# Amended Ground Floor Planning Drawing

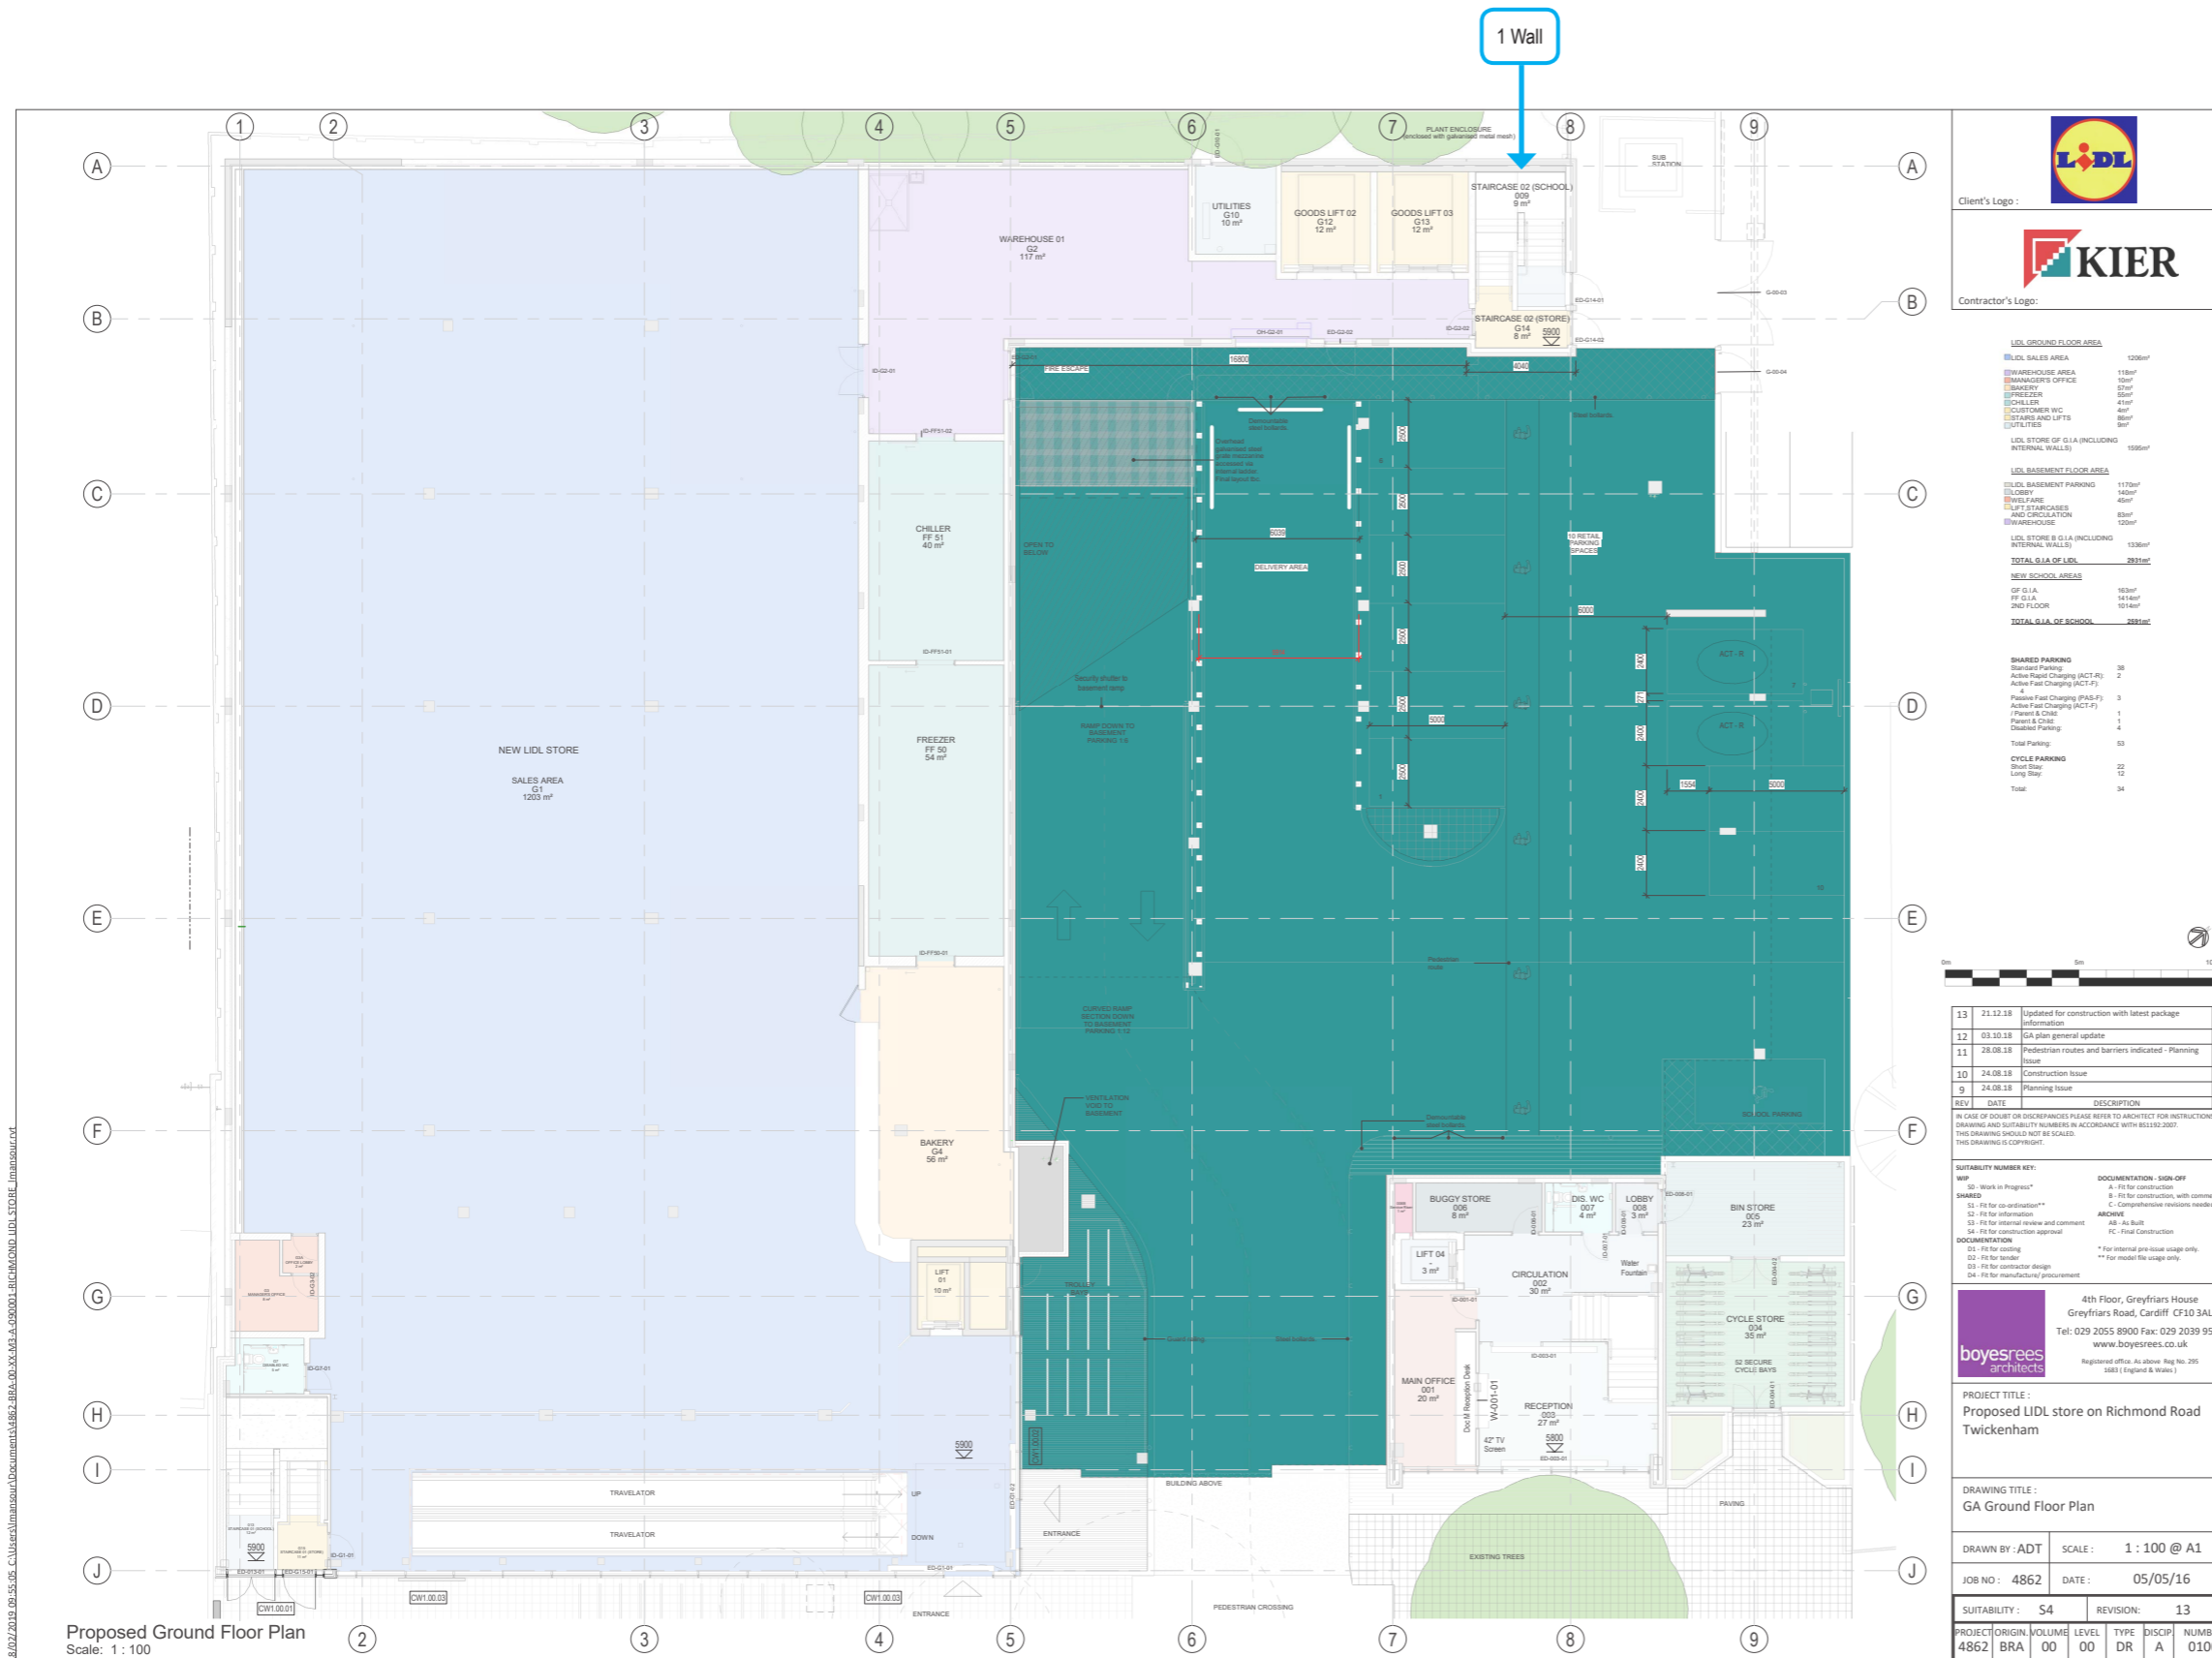
- Proposed Change: Glazed stair core omitted and rear escape combined with store staircase.  
Reasons: Rear escape stair rationalised to reduce wasted space and avoid exposed unoccupied space. Removing the stairwell also reduces massing.
